Our Ref: BR-2025-00364-A

BUSHFIRE PLANNING & DESIGN**BUSHFIRE REPORT ADDENDUM****239 MCCARRS CREEK ROAD CHURCH POINT 2105**

RFS REFERENCE: DA20230919004137-Original-1

Figure A - minimum 40m Managed land to the south.

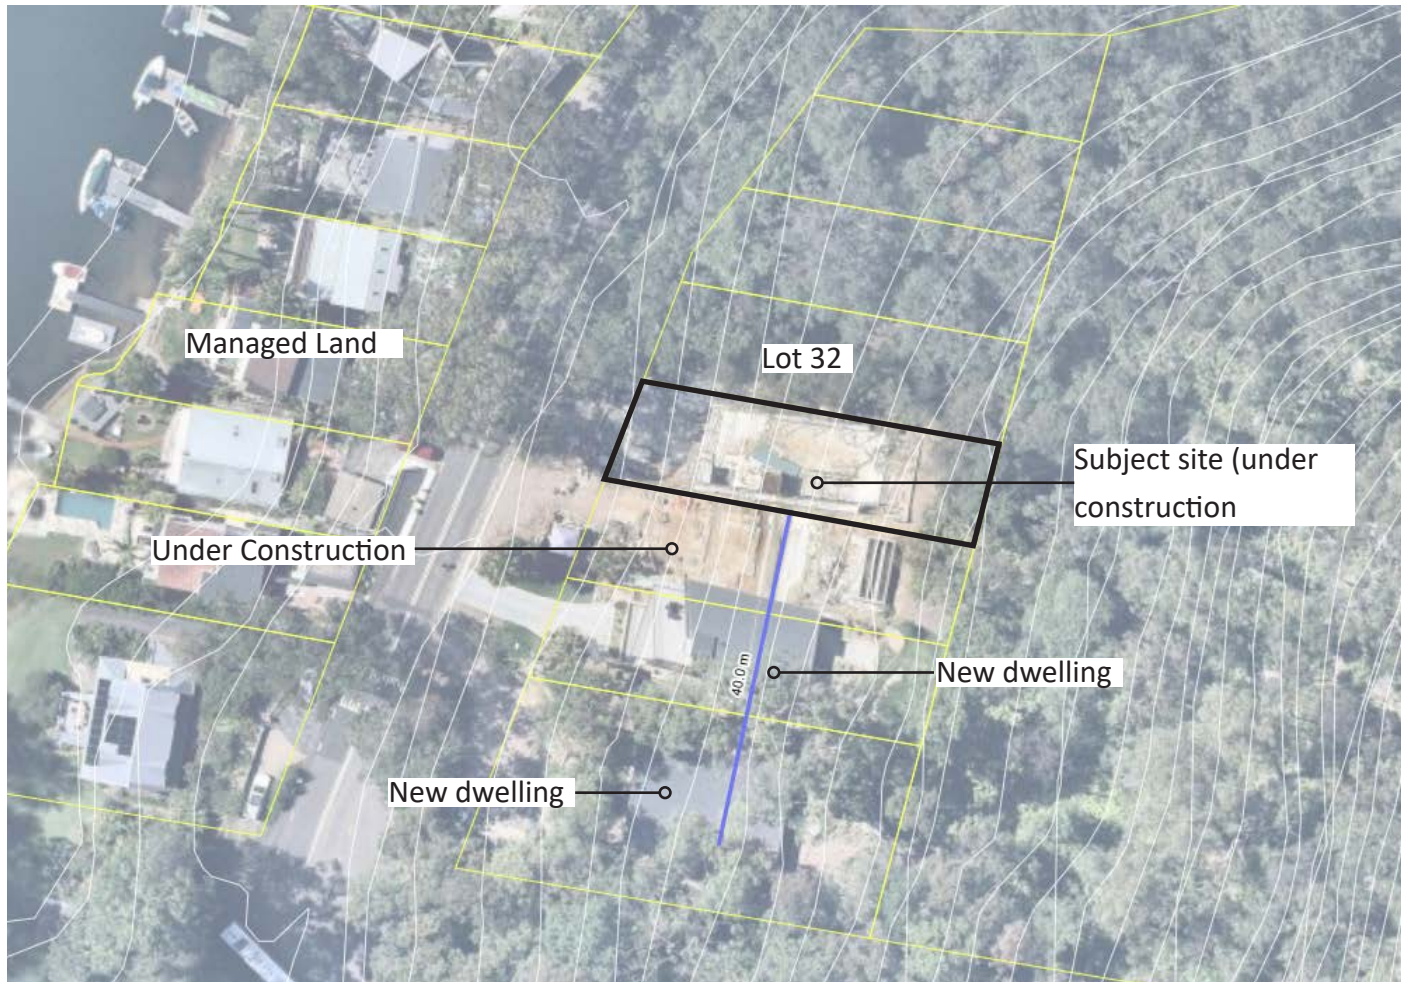
Figure A (below) shows how new dwellings to the south have removed vegetation and established **at least 40 m** of managed land. This development significantly lowers bushfire risk from that direction.

Figure B- Third Floor Plan

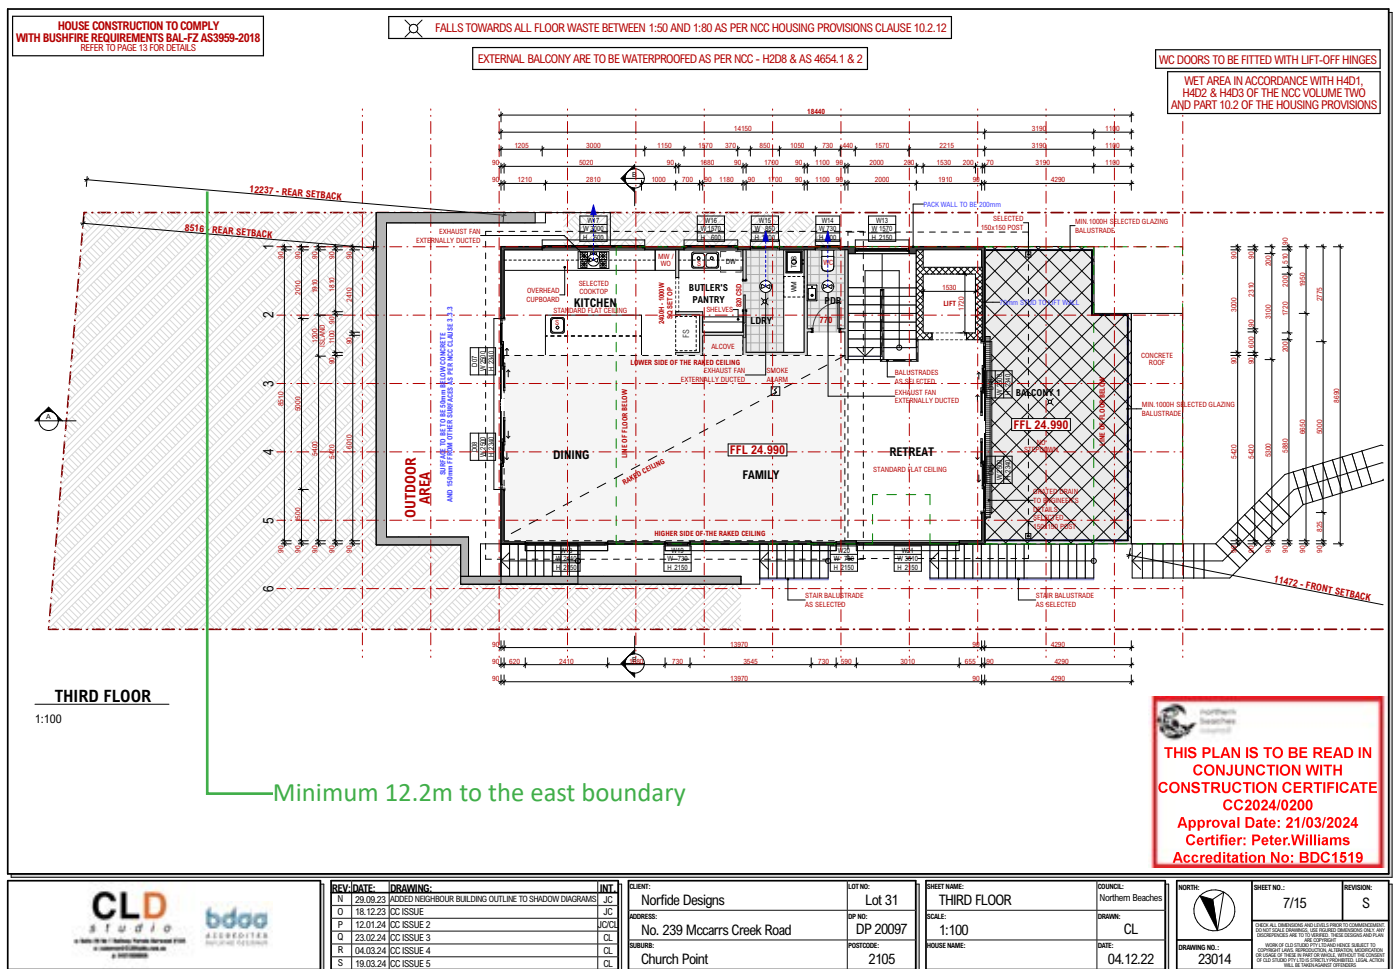
The eastern boundary features vegetation on a steep **up-slope**. The distance to vegetation is **12.2 m** (see **Figure B**, Third Floor Plan). Per RFS requirements, the slope has been capped at 10° for modeling, and the building height on that side is **4.2 m**.

The dwelling is partially cut into the hillside, offering some shielding from potential fire. Although we have not formally quantified the retaining wall's shielding effect, a Method 2 model indicates a radiant heat load of 35.73 kW/m² (BAL-40) on the eastern facade.

Figure C- Site Section

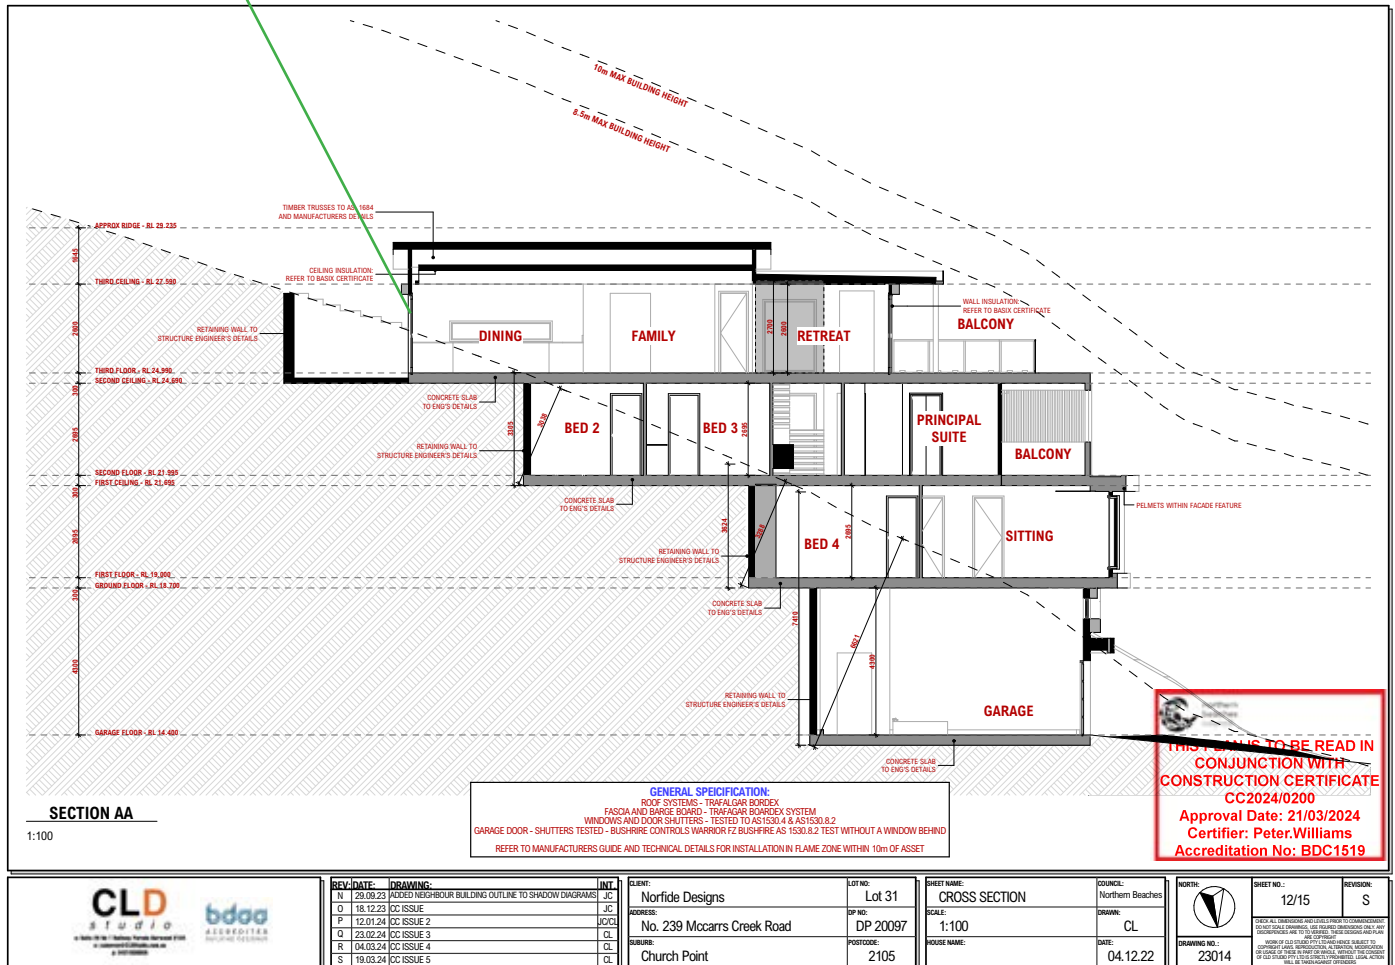
The eastern elevation is largely shielded by the retaining walls cut into the hillside. Our Method 2 model does not rely on shielding. Relies only on the calculation of the up-slope. The calculated radiant heat (without shielding) is 35.73 kW/m² (see Figure D).

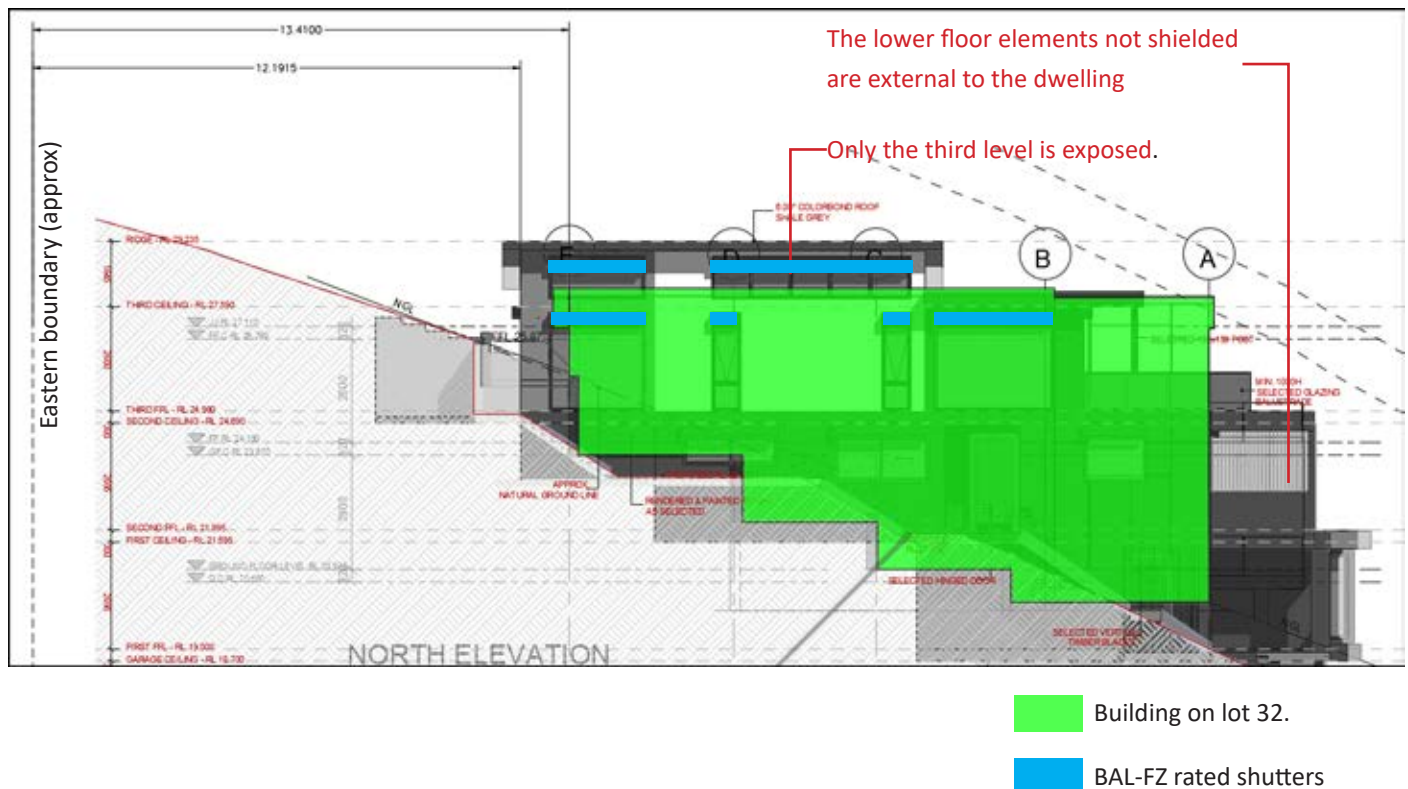
The proposed dwelling at 239 Mccarrs Creek Road will also be partially shielded by the future building on Lot 32, once it is constructed. Because that building does not yet exist, we recognize that full shielding is not currently guaranteed; accordingly, we propose maintaining BAL-FZ construction for the roof and the northern facade and BAL-FZ rated shutters for the north elevation. When the building on lot 32 (#237) is constructed and shielding is demonstrated, the applicant will lodge a second 4.55 modification to remove the bushfire shutters from the lower levels (0, 1 & 2). The bushfire shutters will be retained on Level 3 as shown below.

•	South and West Facades: May be constructed to BAL-40 without compromising overall bushfire protection (since vegetation to the south has been cleared and there is less exposure for the southern and western aspects).
•	East Facade: Although partially shielded by the retaining wall, we recommend a non-combustible shutter system. Our modeling shows radiant heat loads do not exceed 40 kW/m² on this side.
•	North Facade and Roof: Retain BAL-FZ construction due to potential interim exposure until the northern allotment is developed. Retain BAL-FZ rated shutters for the Level 3 north elevation (see above markup).
